NSLPP MEETING HELD ON 06/08/2025

ADDRESS/WARD: 29 Tobruk Avenue, Cremorne 2090 (W)

APPLICATION NO: DA 110/25

PROPOSAL: Part demolition, extension, renovation and lift installation to an existing three storey house and garage extension

Figure 4 (right): Proposed First Floor Plan

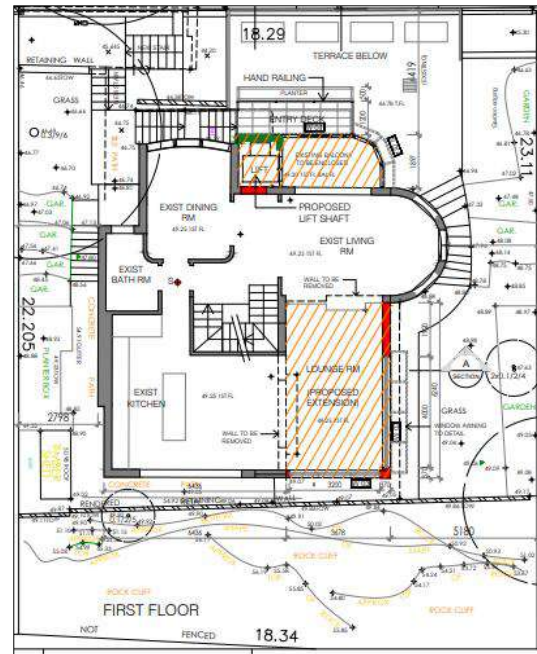
A condition is recommended at the end of the report for the entry deck proposed on the First Floor to be reduced in width from 1.2m to 1m. The planter box proposed to be affixed to the entry deck is to increase in front setback in accordance with the reduction in width of the entry deck to comply with the minimum 3m front setback stipulated in the Area Character Statement.

- A4. The proposed Entry Deck located on the First Floor is to be reduced in width from 1.2m to 1m. The proposed planter box affixed to the balustrade of the Entry Deck is to move east with the Entry Deck structure accordingly.

5. Height of Building

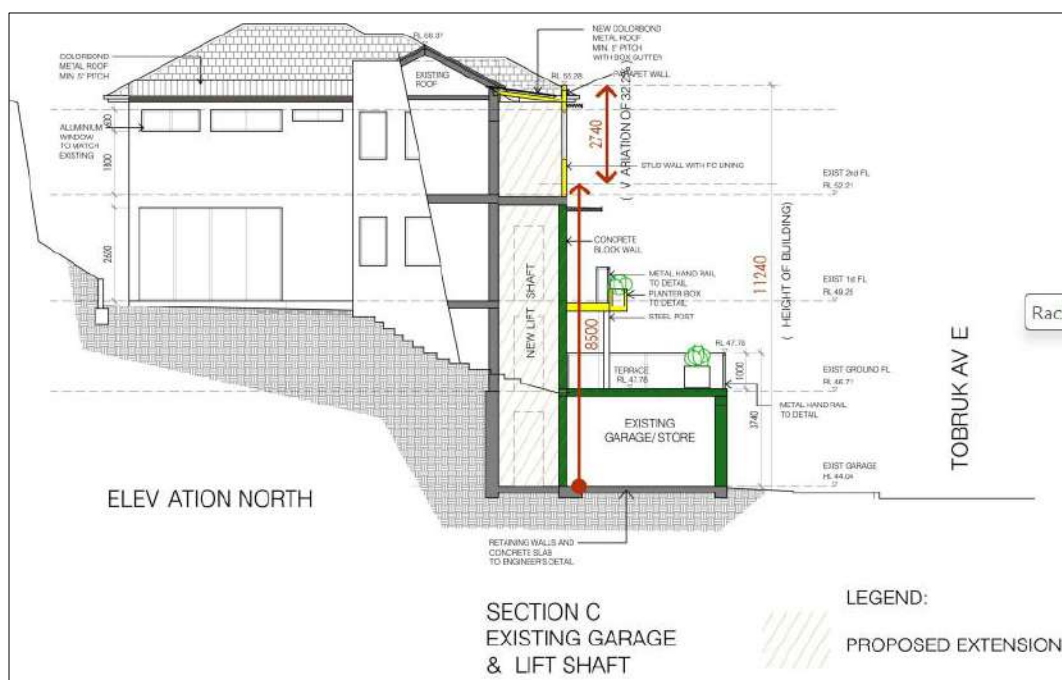
North Sydney Local Environmental Plan 2013				
Site Area – 411m ²	Existing	Proposed	Control	Complies
Clause 4.3 – Heights of Building	11.3m RL 56.37 Roof ridge east (rear) of front balconies	11.24m Measured from Existing Garage Level to Top of Parapet RL55.28.	8.5m	No Variation 2.74m (32.24%)

In conclusion, the written request seeking a variation to the building height control is considered to be satisfactory, has demonstrated that compliance with the standard is unreasonable and unnecessary in the circumstances of the case and has provided environmental planning grounds which support the request. While the breach to the building height standard exceeds a 10% variation, it is consistent with the objectives of the building height control and the R2 Low Density Residential zone.

Figure 12: Proposed excavation 2.9m for the garage extension

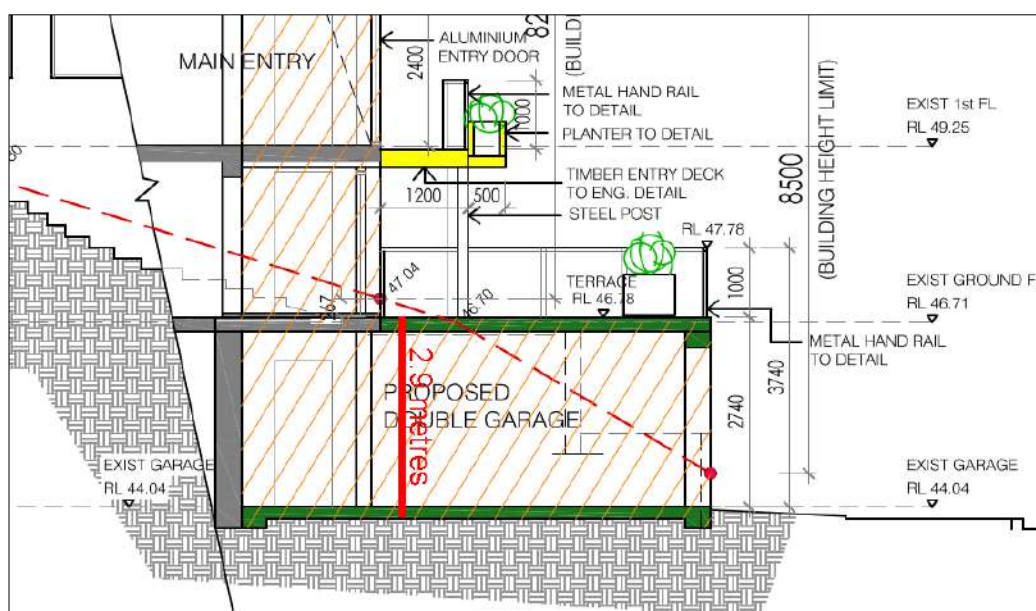
The proposal involves some excavation so an assessment has been carried out below having regard to Clause 6.10 in *NSLEP 2013*.

The proposal involves some excavation for the lift and extension to the garage at the front of the property and minor surface preparation for the addition at the rear of the property only and is therefore satisfactory against Clause 6.10 in *NSLEP 2013*. The maximum proposed excavation is 2.9m for the proposed garage extension from the garage floor level to the ground floor level.
